Addendum 1 for RFB927940-04

Project Name: WRC Decentralization Phase 4 & Fire Alarm Phase 3 (9279.40 & 9279.41) Bid Issuance #4
DAS RFB #: 927940-04
DAS Project #: 9279.40 & 9279.41
Date: 5/21/2026

CHANGES TO DRAWINGS

A6 SECOND FLOOR THERMOSTAT PLAN
1/16" = 1'-0" 0" 24'

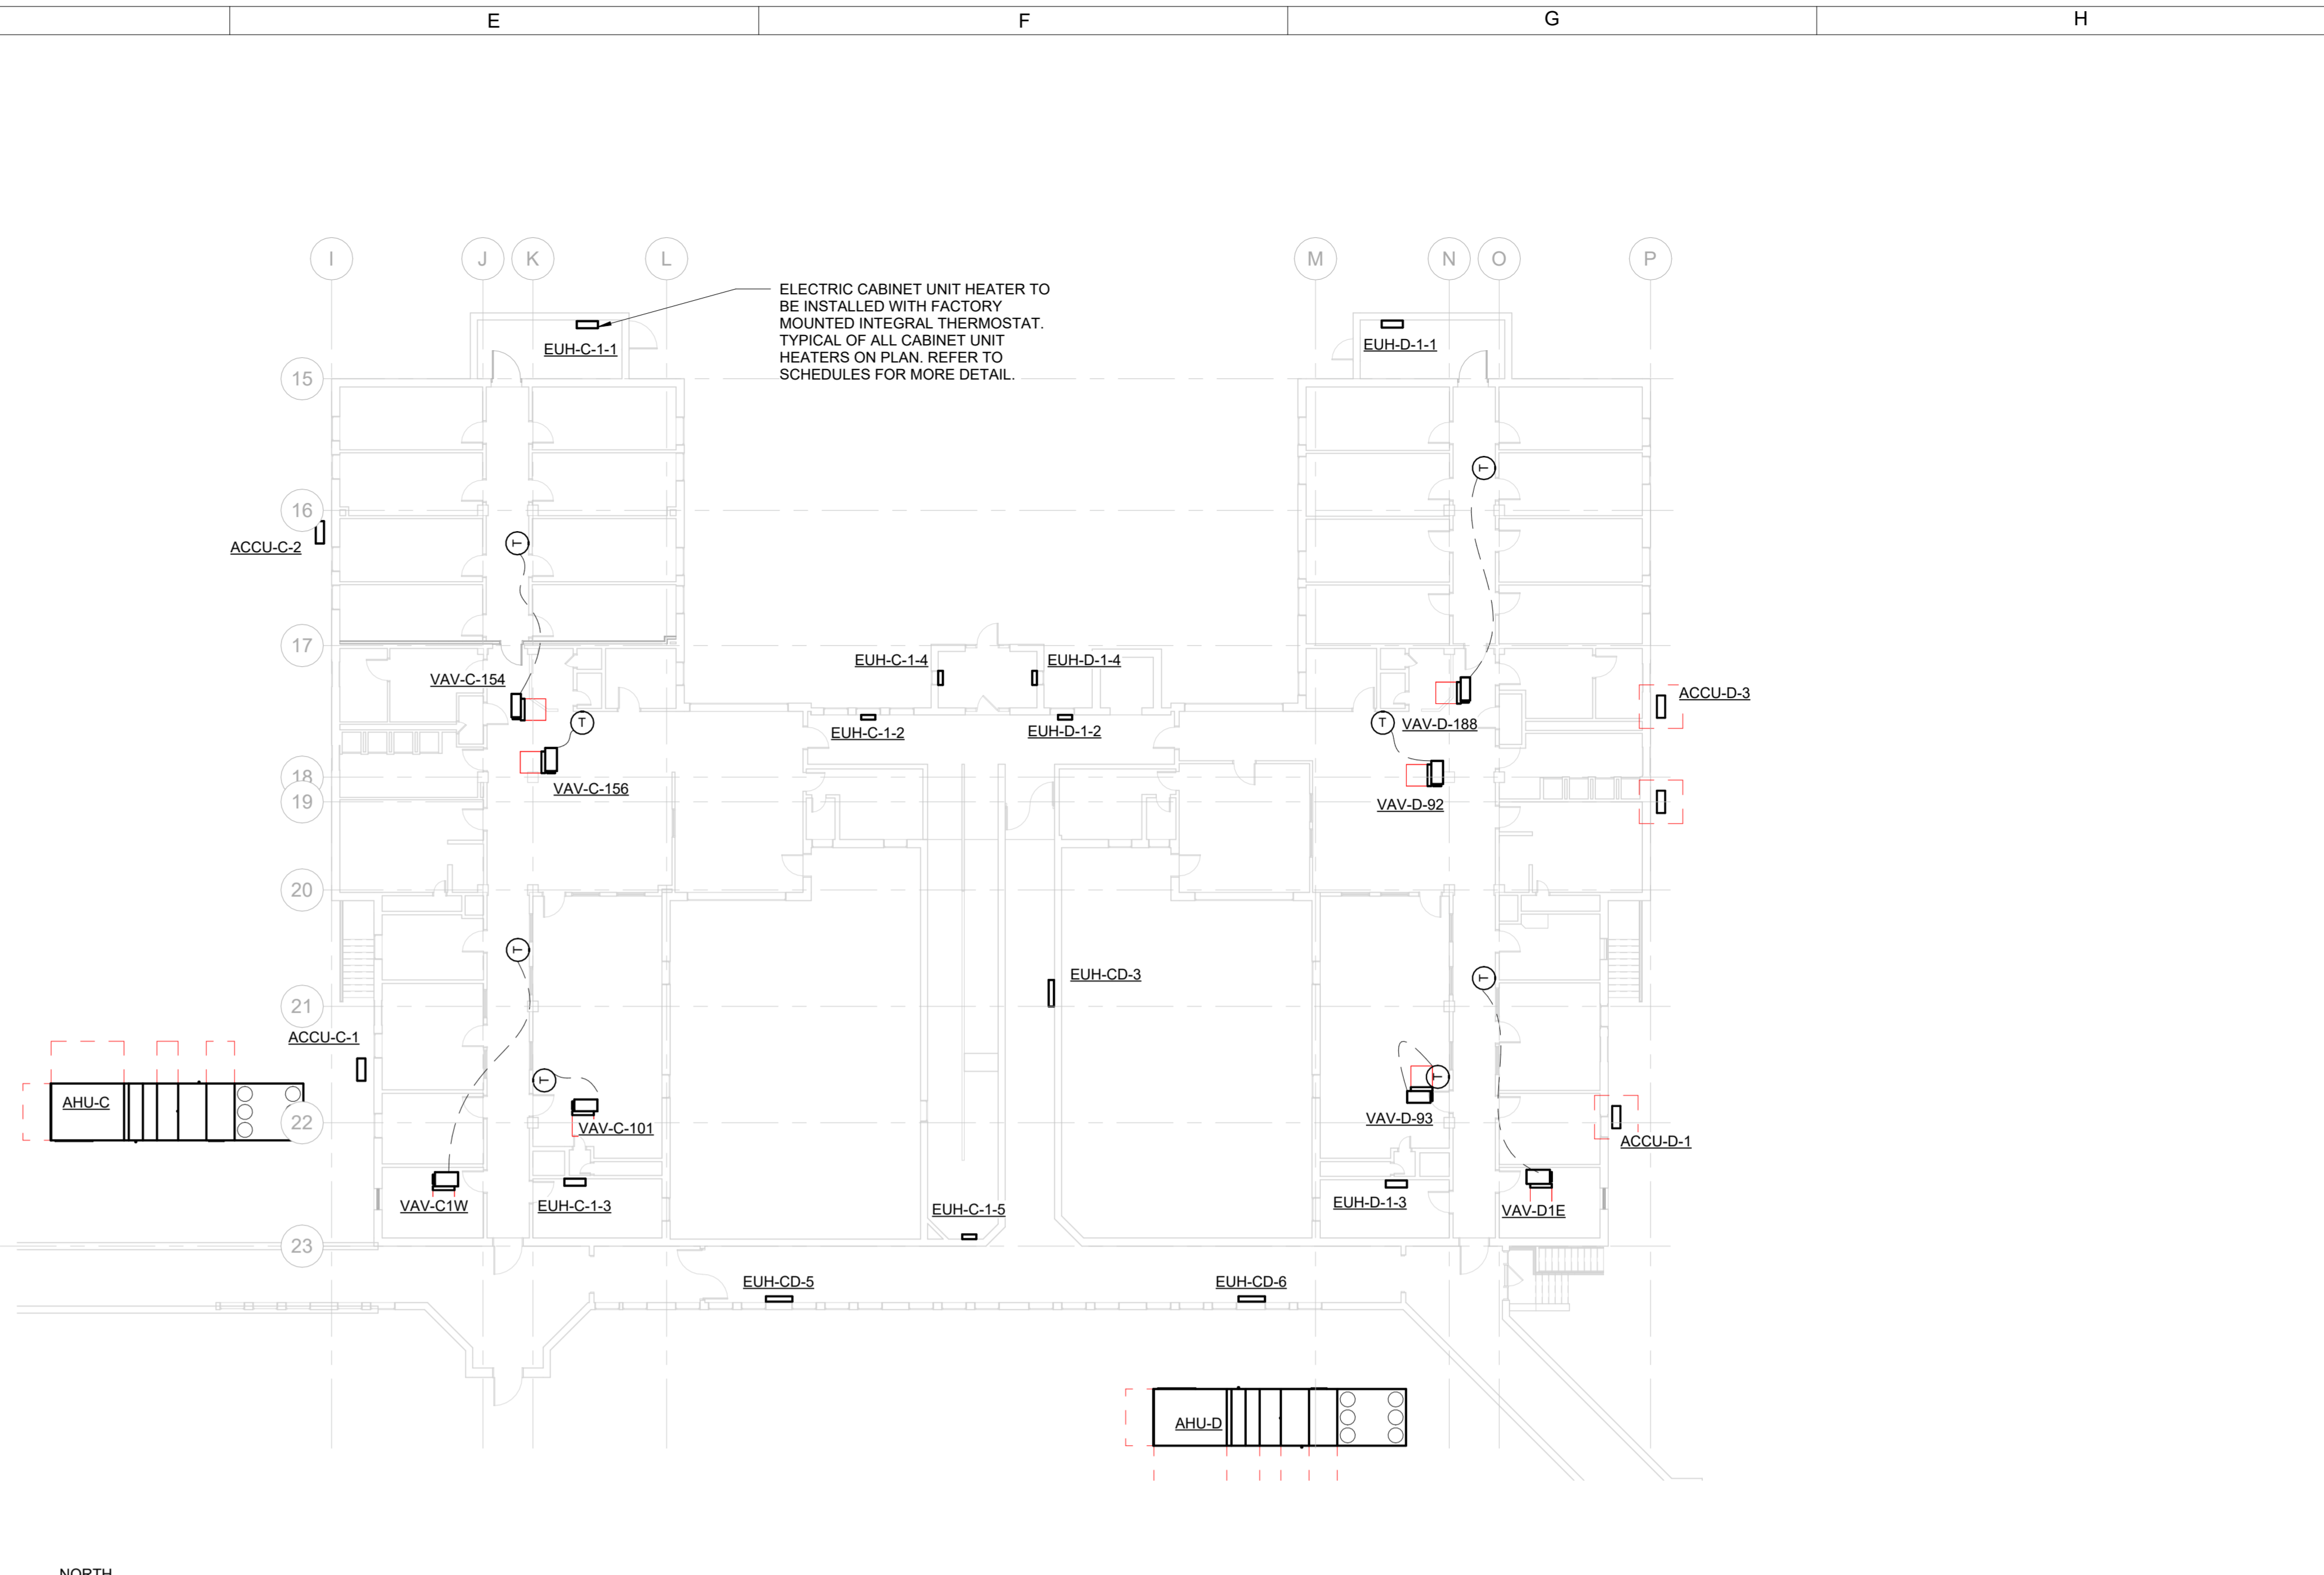
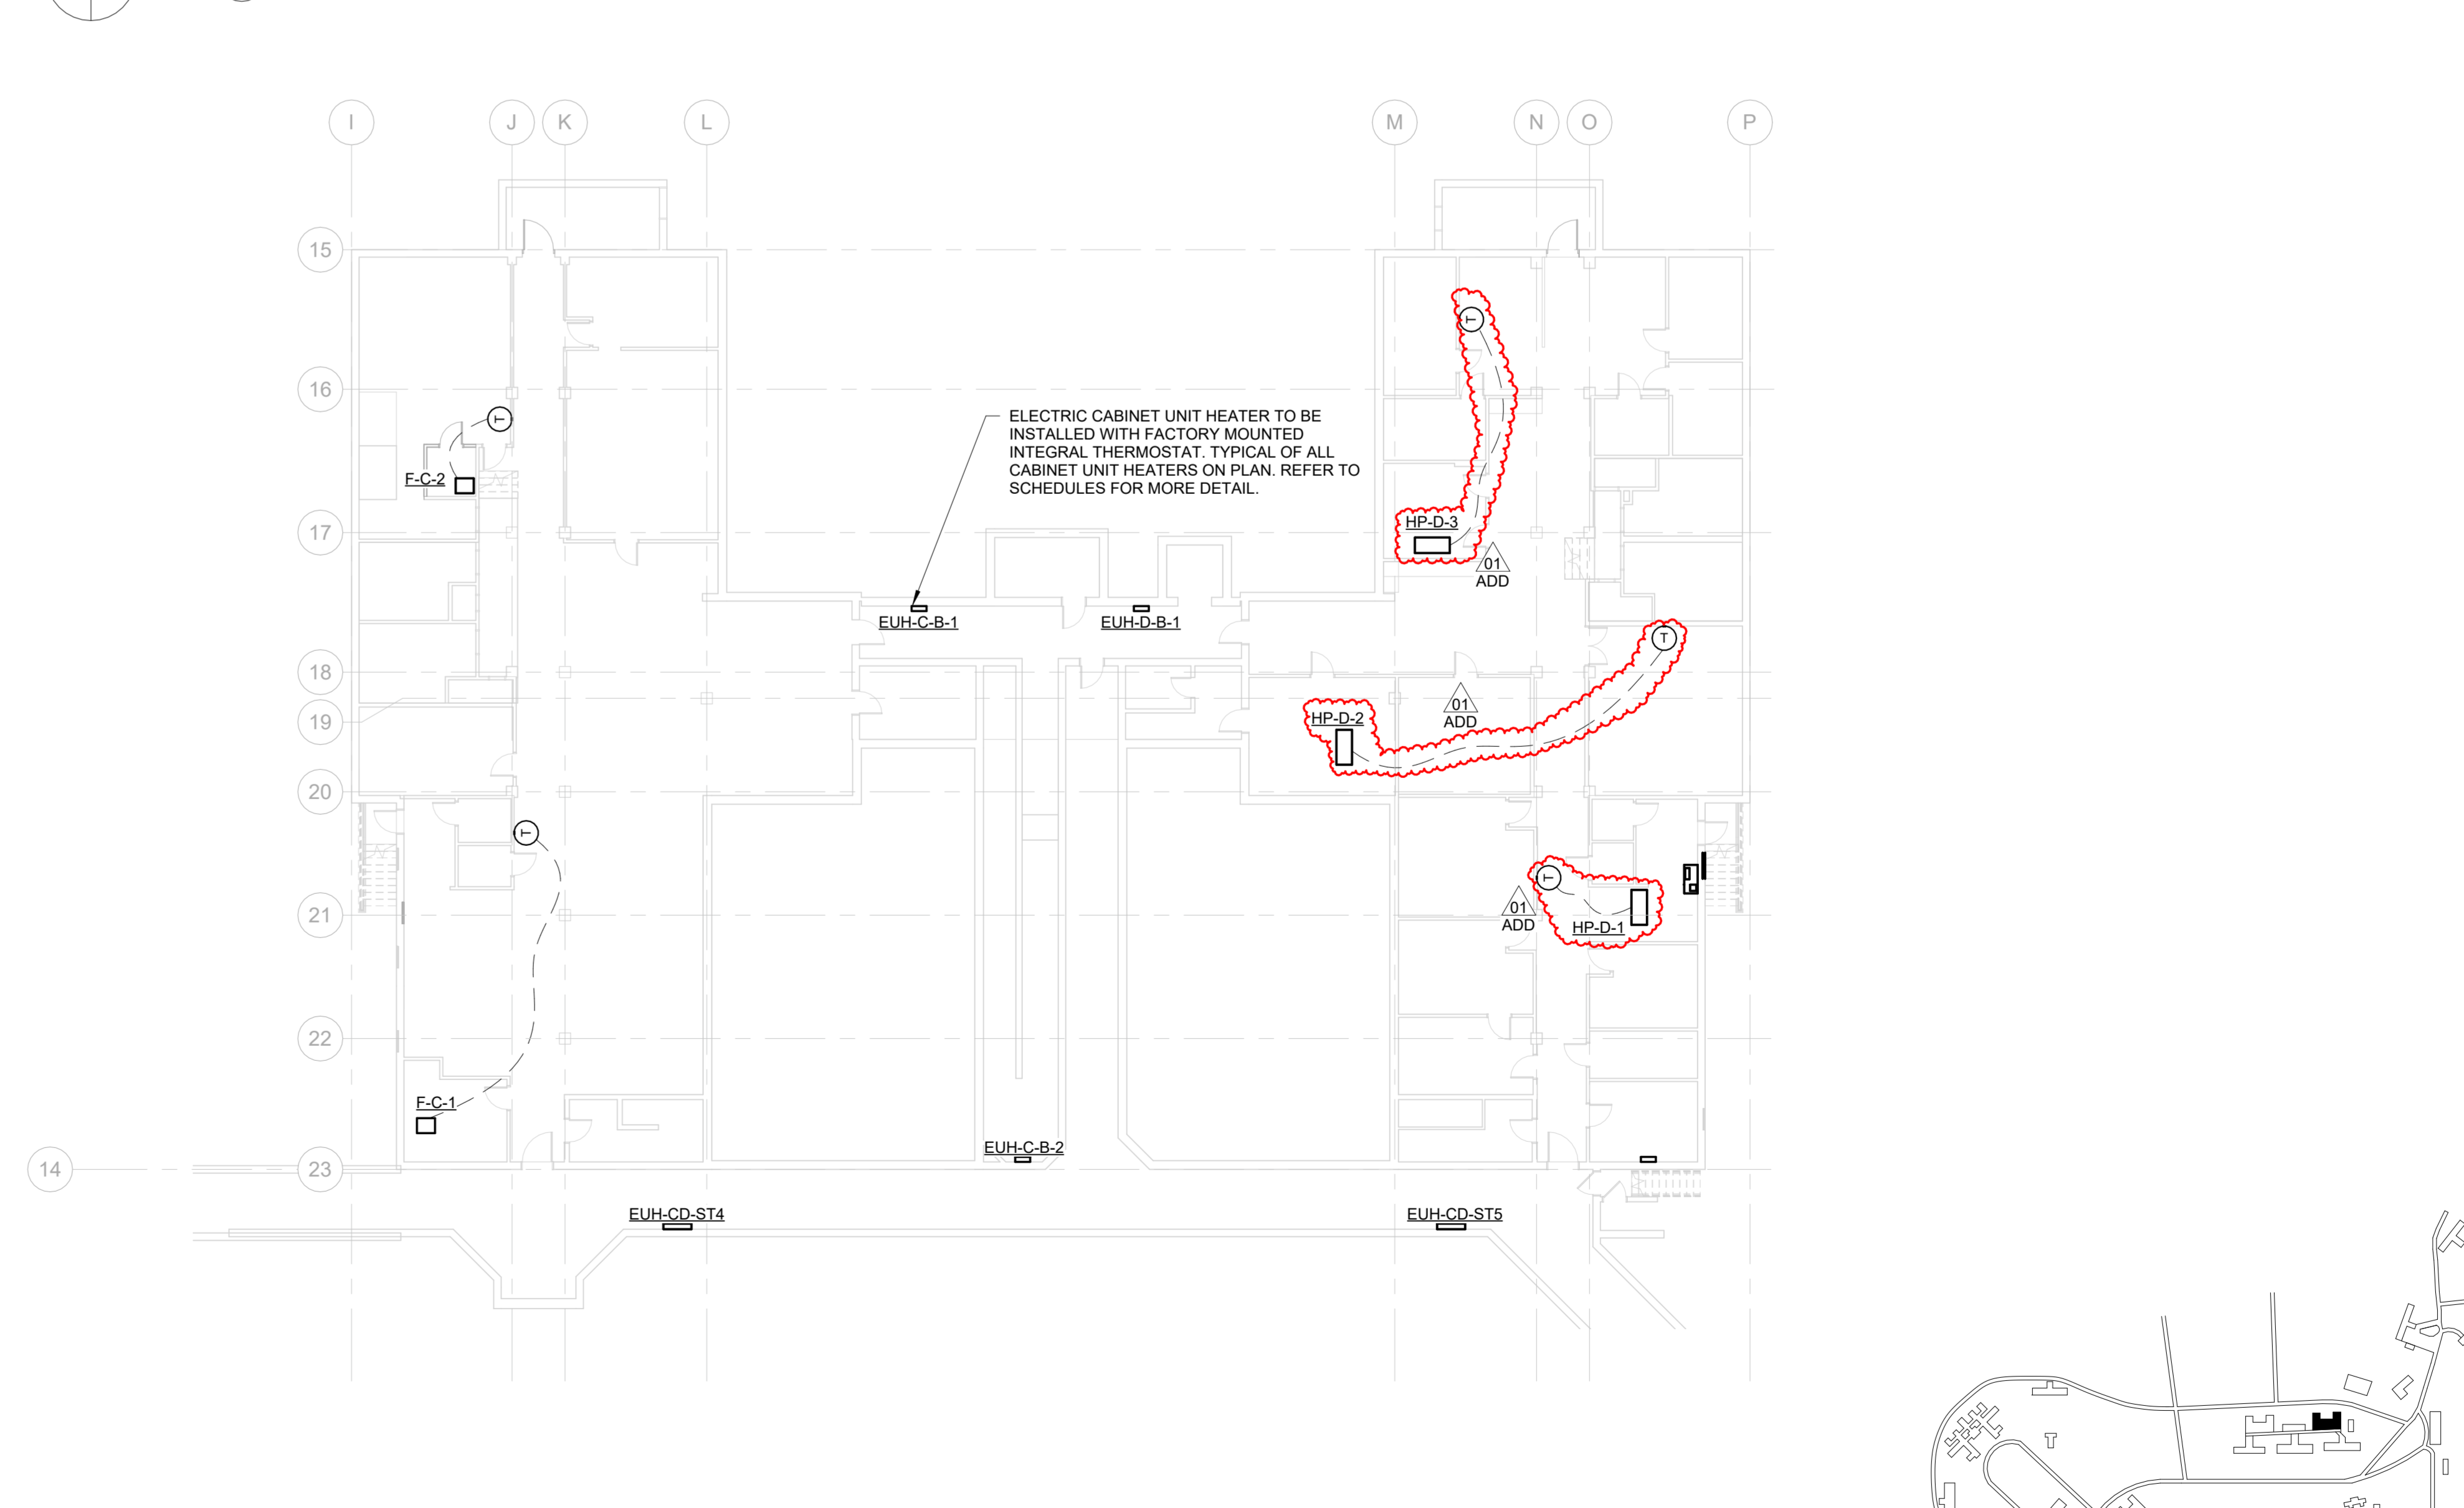
- **ADD** Keynote 13-M32
- **13-M300 – THERMOSTAT PLAN:**
 - **REVISE** thermostats in Area D Basement.
- **13-M501 –MECHANICAL CONTROLS:**
 - **ADD** ERV control sequence.
